**Changes to the Radiation Budget Instrument (RBI)  
Performance Requirements Document (IPRD – Exhibit C)**

**FROM:** Draft RFP Release Version      **TO:** Final RFP Release Version (Baseline)

NASA Langley Research Center  
Document Date: May 31, 2013

**Figure 4.1.1.1-1:**

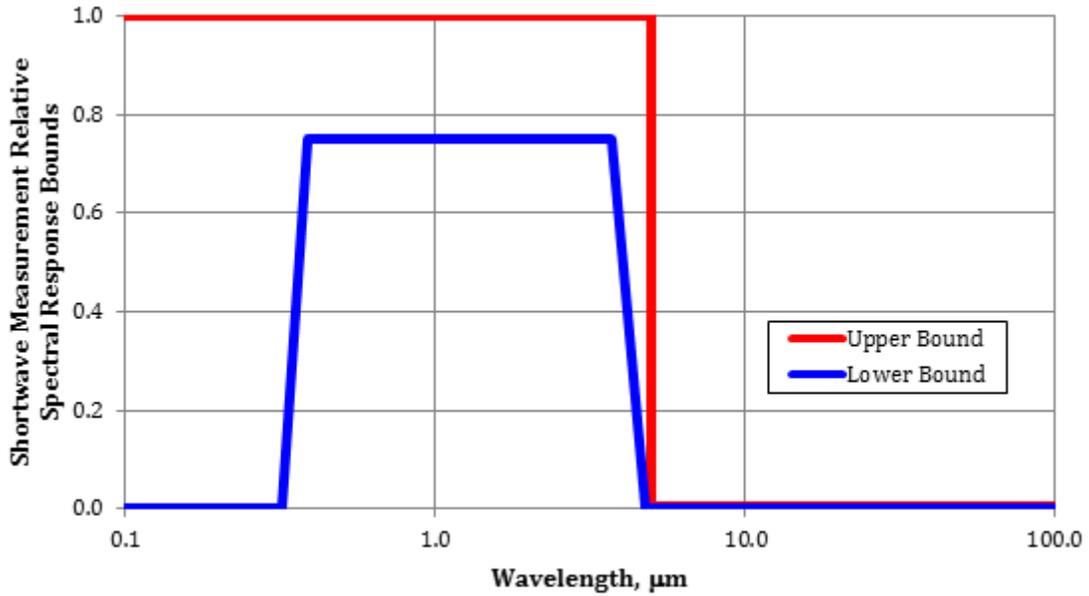
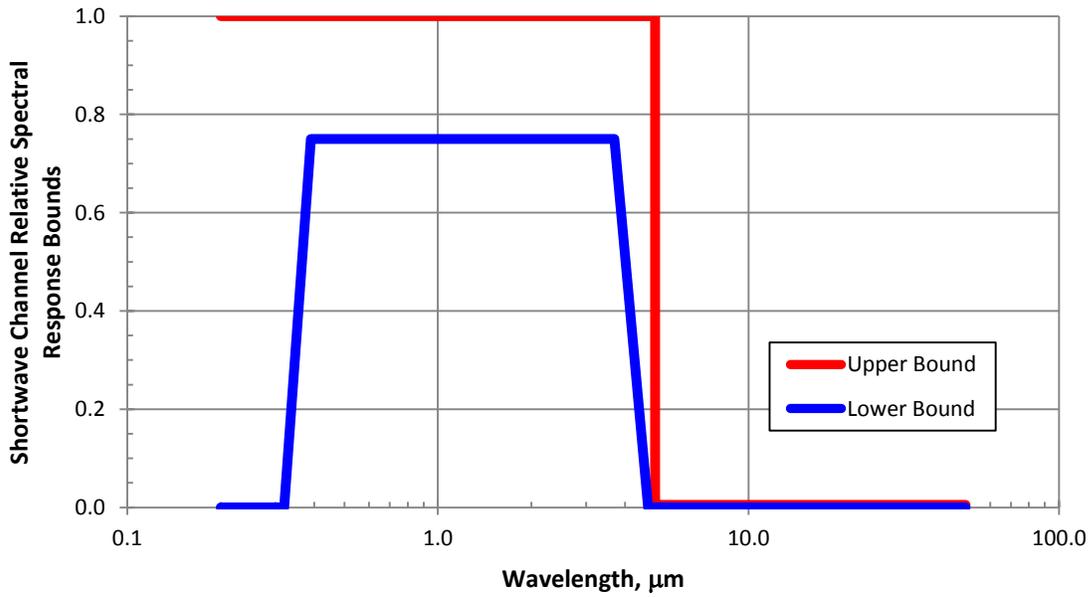
<b>Wavelength, micron</b>	<b>Lower Bound</b>	<b>Upper Bound</b>
0.100	0.000	1.000
0.320	0.000	1.000
0.390	0.750	1.000
3.700	0.750	1.000
4.750	0.000	1.000
5.000	0.000	1.000
5.000	0.000	0.005
100.000	0.000	0.005

<b>Wavelength, micron</b>	<b>Lower Bound</b>	<b>Upper Bound</b>
0.200	0.000	1.000
0.320	0.000	1.000
0.390	0.750	1.000
3.700	0.750	1.000
4.750	0.000	1.000
5.000	0.000	1.000
5.000	0.000	0.005
50.000	0.000	0.005

**Figure 4.1.2.1-1:**

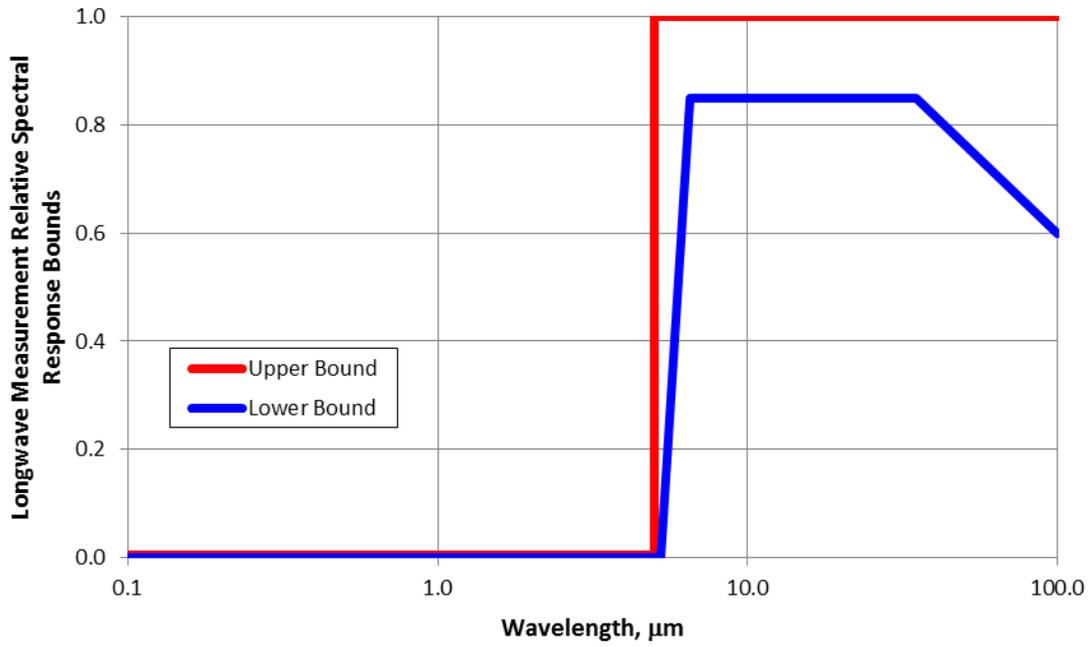
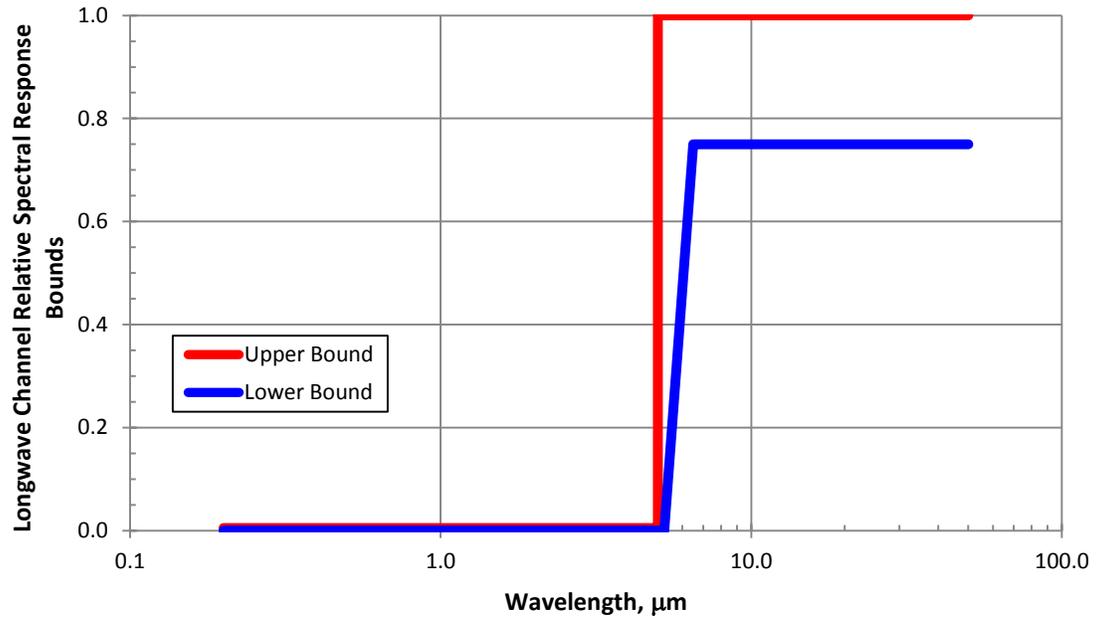
<b>Wavelength, micron</b>	<b>Lower Bound</b>	<b>Upper Bound</b>
0.100	0.000	0.005
5.000	0.000	0.005
5.000	0.000	1.000
5.250	0.000	1.000
6.500	0.850	1.000
35.000	0.850	1.000
100.000	0.600	1.000

<b>Wavelength, micron</b>	<b>Lower Bound</b>	<b>Upper Bound</b>
0.200	0.000	0.005
5.000	0.000	0.005
5.000	0.000	1.000
5.250	0.000	1.000
6.500	0.750	1.000
50.000	0.750	1.000

**Figure 4.1.3.1-1:**

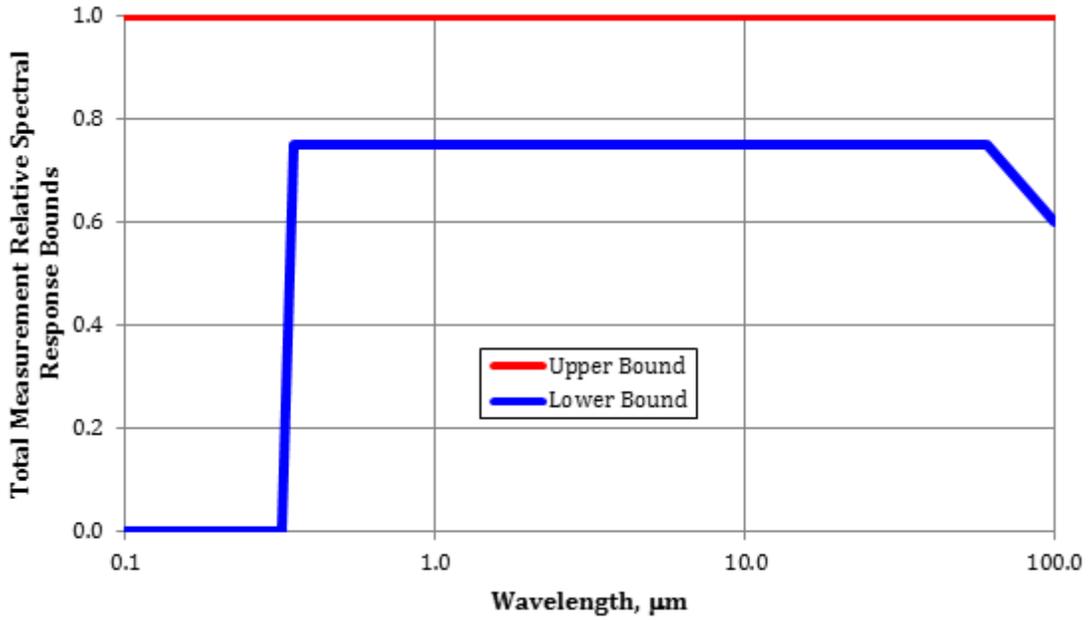
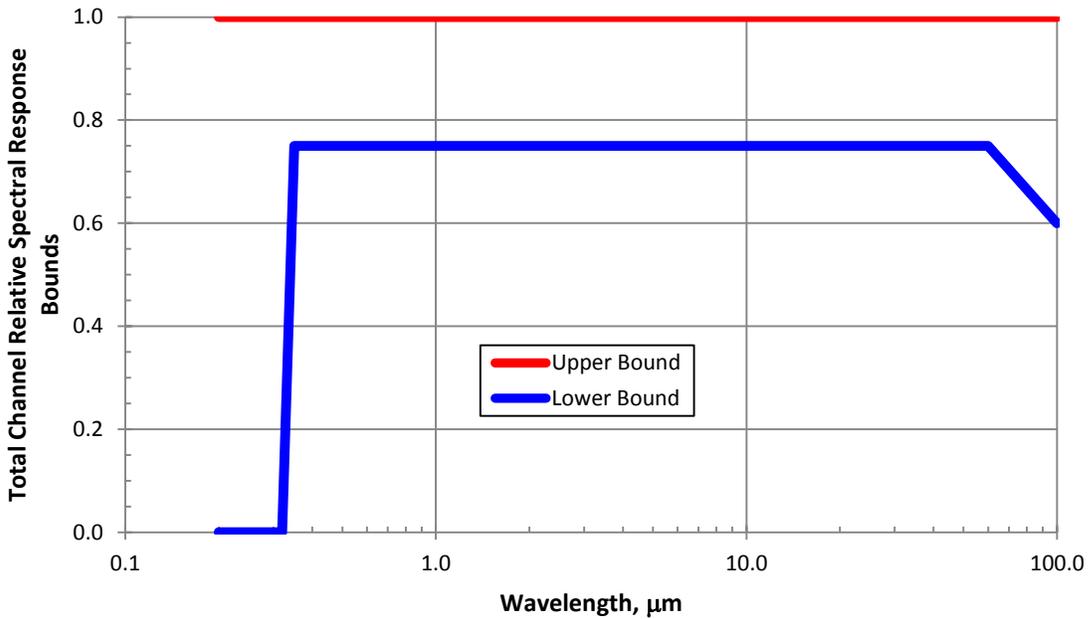
<b>Wavelength, micron</b>	<b>Lower Bound</b>	<b>Upper Bound</b>
0.100	0.000	1.000
0.320	0.000	1.000
0.350	0.750	1.000
60.000	0.750	1.000
100.000	0.600	1.000

<b>Wavelength, micron</b>	<b>Lower Bound</b>	<b>Upper Bound</b>
0.200	0.000	1.000
0.320	0.000	1.000
0.350	0.750	1.000
60.000	0.750	1.000
100.000	0.600	1.000

**Figure 4.2.4-2:**

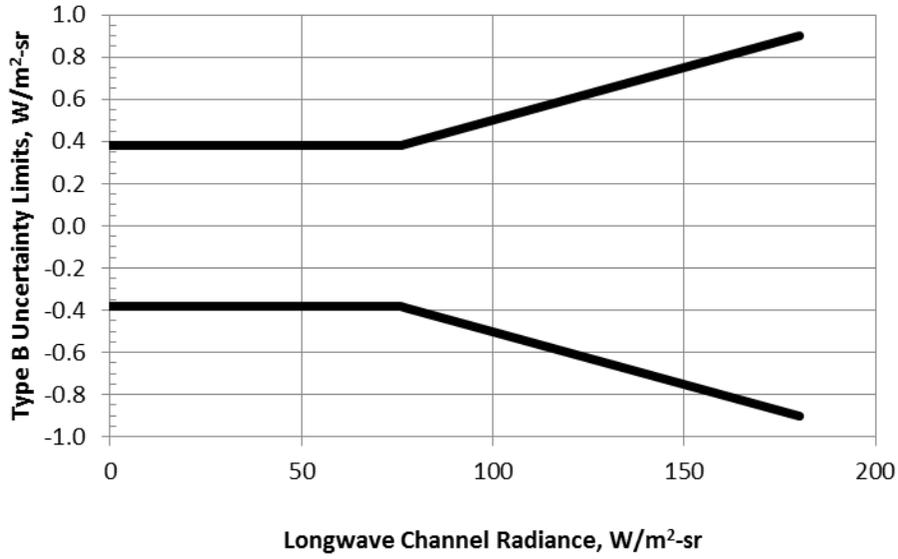
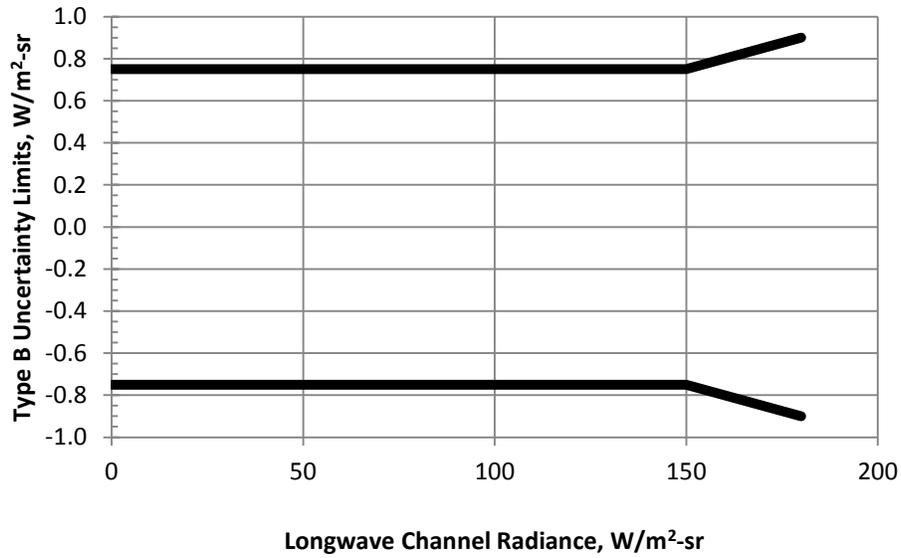
The Instrument shall have Type B standard uncertainty of  $\pm$  the larger of 0.380 W/m<sup>2</sup>-sr or 0.5% of  $L_E$  in the Longwave Channel for all Earth-viewing radiances as shown in Figure 4.2.4-2.

The Instrument shall have Type B standard uncertainty of  $\pm$  the larger of 0.750 W/m<sup>2</sup>-sr or 0.5% of  $L_E$  in the Longwave Channel for all Earth-viewing radiances as shown in Figure 4.2.4-2.

**Figure B-4 Definition of Viewing Zenith Angle**

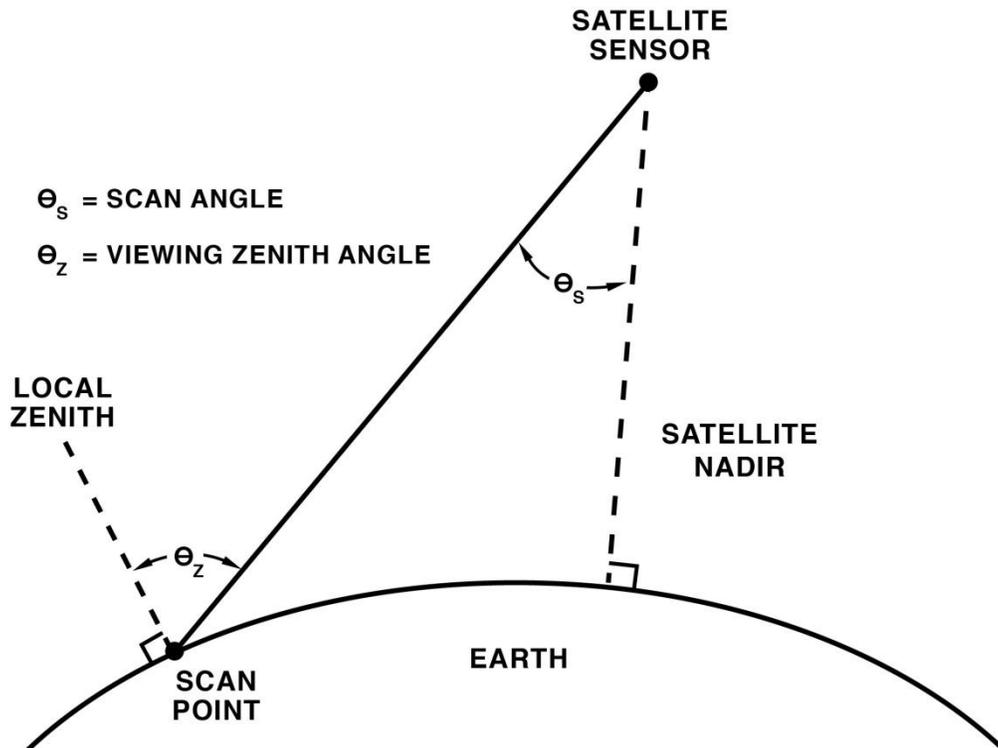
**ADDED** Definitions Table Entry and New Figure B-4 to define viewing zenith angle.
